HISTORIC AND DESIGN REVIEW COMMISSION

HDRC CASE NO: 2023-151
ADDRESS: 521 RIVERWALK
LEGAL DESCRIPTION: NCB 914 BLK LOT 11 (RIVER RESTAURANTS SUBD)
ZONING: D, H, RIO-3
CITY COUNCIL DIST.: 1
DISTRICT: Alamo Plaza Historic District
APPLICANT: Tania Gunn/Beaty Palmer Architects
OWNER: Chris Moser/LOSOYA STREET PROPERTIES LLC
TYPE OF WORK: Construction of outdoor decks for seating, construction of an outdoor bar
APPLICATION RECEIVED: April 13, 2023
60-DAY REVIEW: Not applicable due to City Council Emergency Orders
CASE MANAGER: Edward Hall

REQUEST:

The applicant is requesting conceptual approval to expand the existing outdoor seating at the river level. The proposed expanded seating will be located over existing planting beds and will include the modification of existing river level elements. The applicant has also proposed to install a bar element at the existing patio seating level.

SCHEME 3
RIVER LEVEL FLOOR PLAN

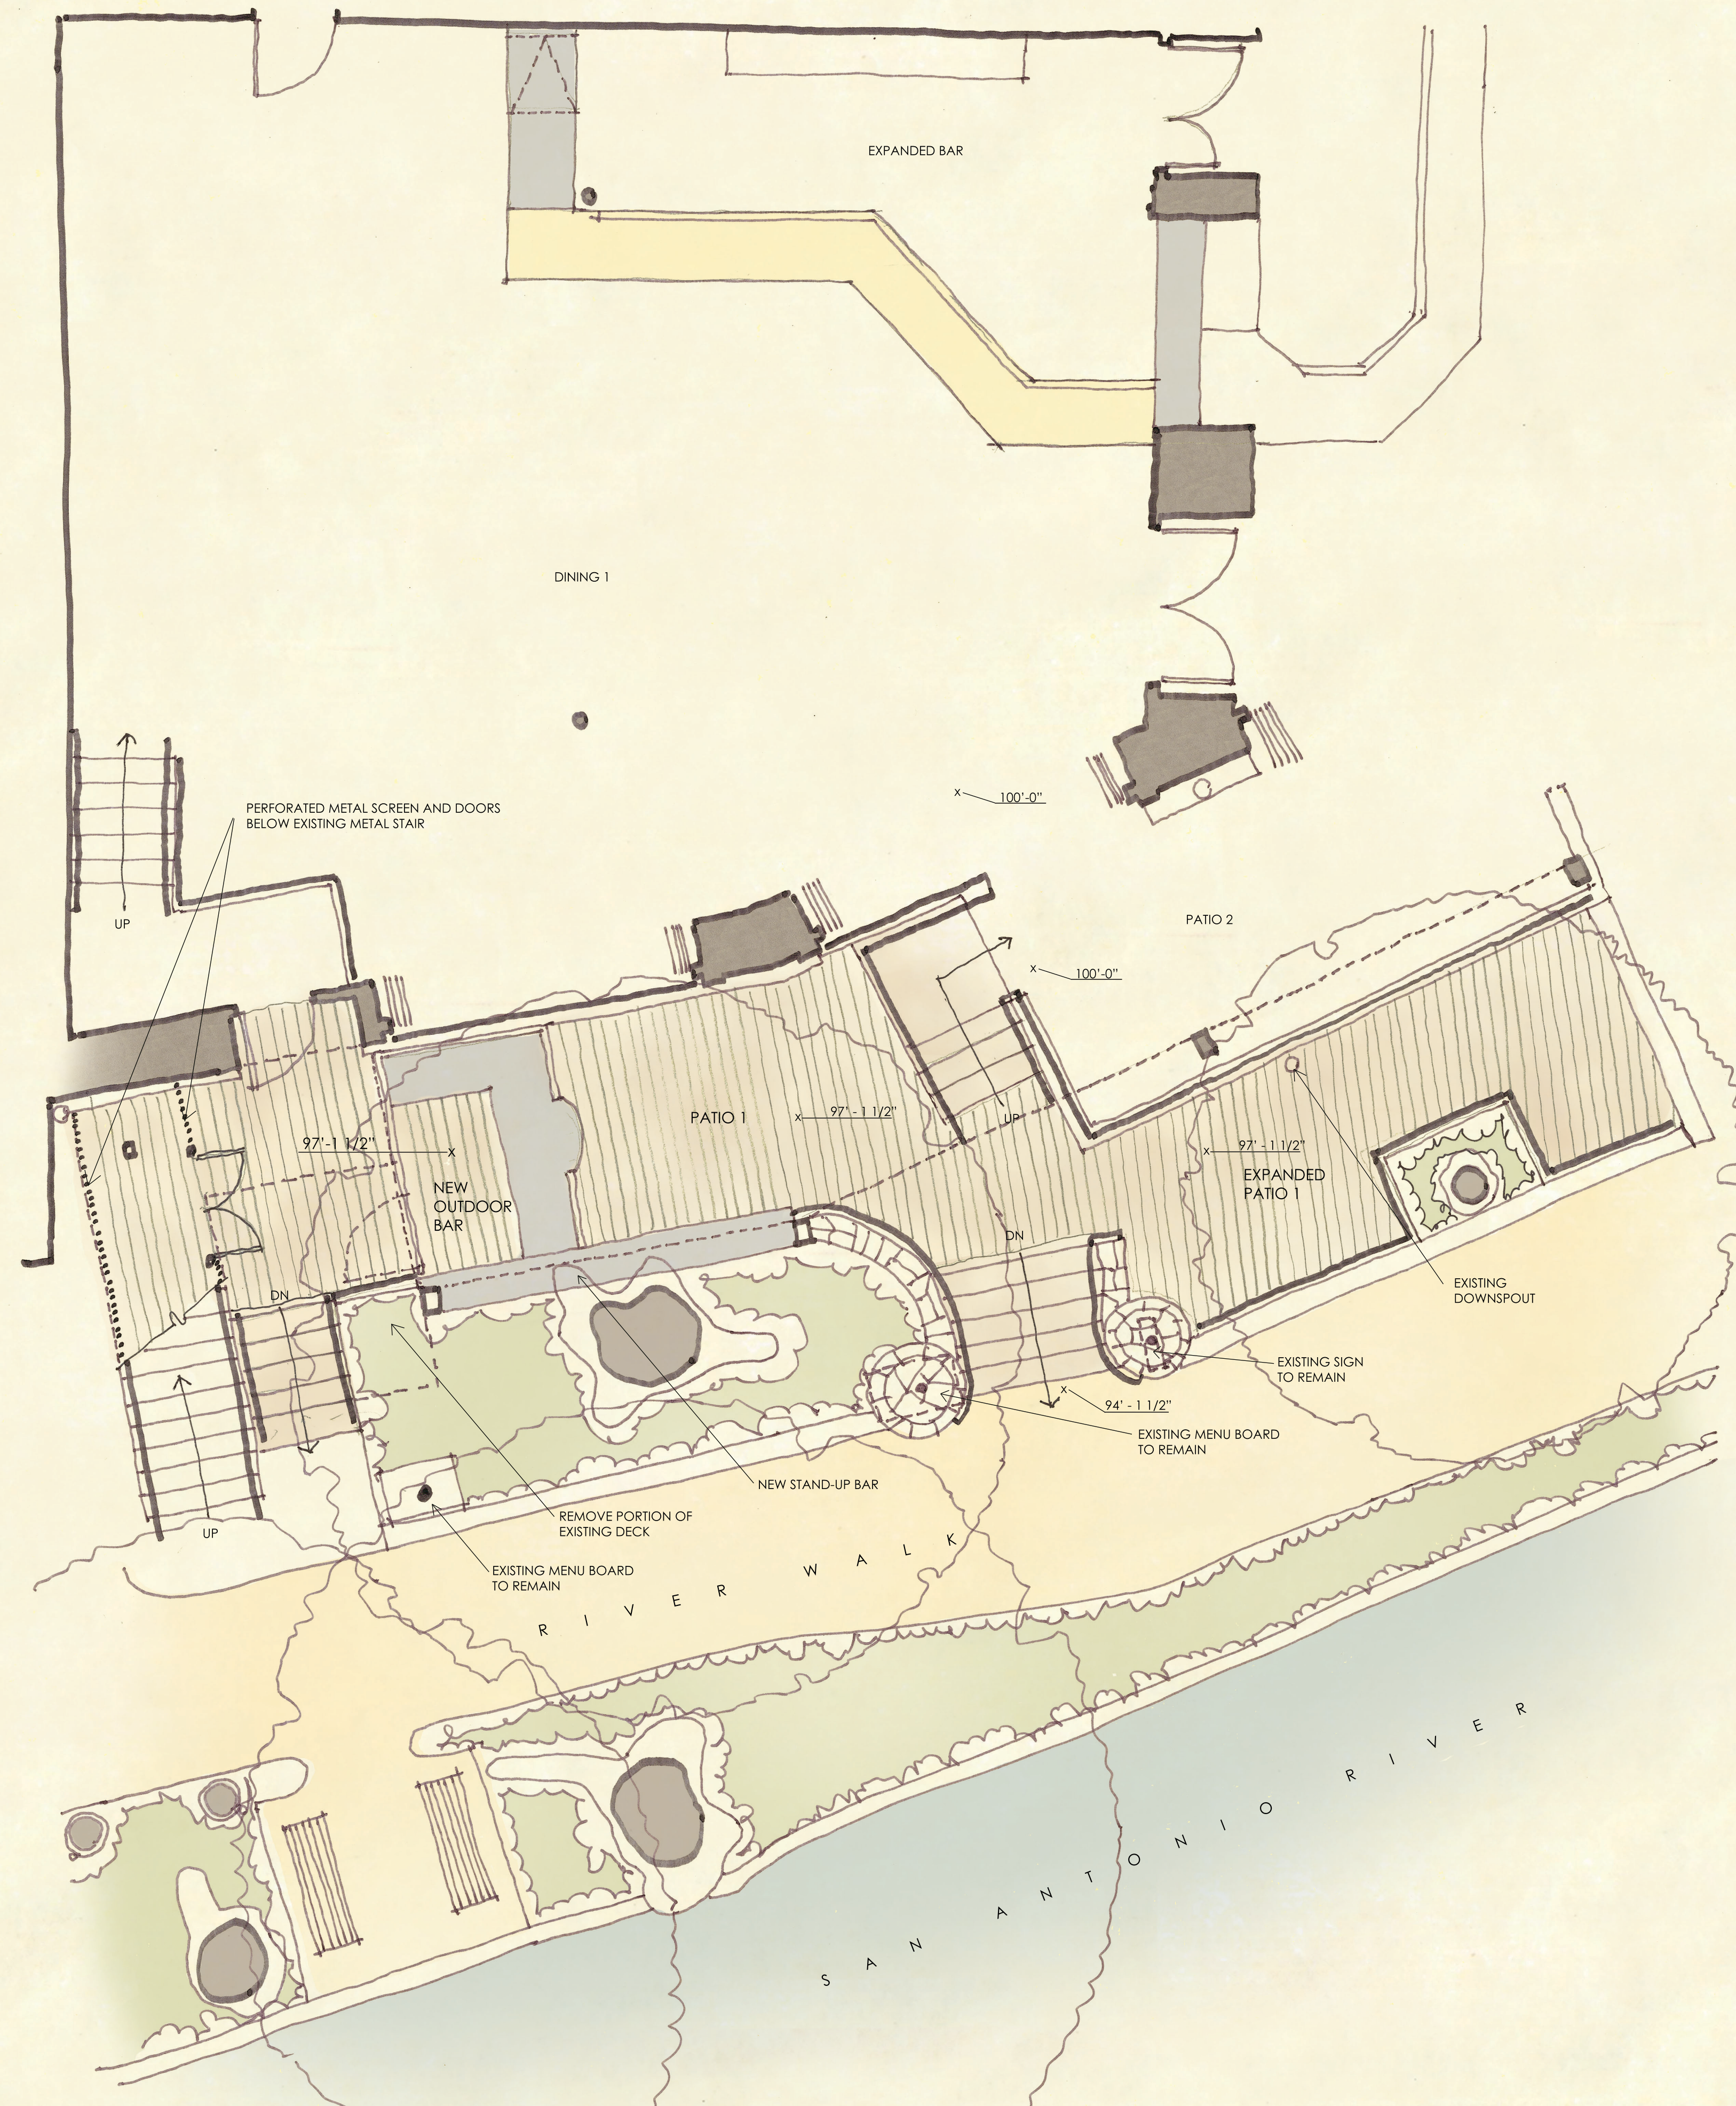
- b. PATIO EXPANSION – The applicant has proposed to expand the existing outdoor seating at the river level in two primary locations. The proposed expansion of patio seating will be located in the locations currently occupied by planting beds. To accommodate for the installation of the proposed seating locations, modifications will be made to existing, non-original river level elements, including non-original walls and stairs. Generally, staff finds the proposed locations and proposed modifications to existing elements to be appropriate. Complete construction documents are to be submitted for review and approval when returning to the Commission for final approval.

- c. PATIO EXPANSION (Materials) – The applicant has proposed materials that include 2x6 composite decking and metal guard rails and handrails. In the location of expanded patio 4, the applicant has proposed to raise an existing, non-original limestone wall. Generally, staff finds the proposed materials to be appropriate. Staff finds that the proposed composite decking should not feature a faux wood grain finish and that railings and guard rails should feature a finish that matches the existing on site. Product specifications and an example of the final installation are to be provided to OHP staff for review. The final decking installation should complement historic River Walk elements. Additionally, staff finds that the raised limestone wall should be done to be complementary to the existing and historic Hugman era stone on site.

- i. That the applicant submits complete construction documents that include materials specifications for review and final approval by the Commission.
- ii. That the proposed decking feature a smooth finish with no faux wood grain, that all new railings and guard rails feature finishes to match the existing on site, and that the introduced limestone be complementary of the existing and Hugman era limestone found on site. Product specifications and an example of the final installation of the proposed decking materials are to be provided to OHP staff for review.
- iii. ARCHAEOLOGY – The project shall comply with all federal, state, and local laws, rules, and regulations regarding archaeology, as applicable.
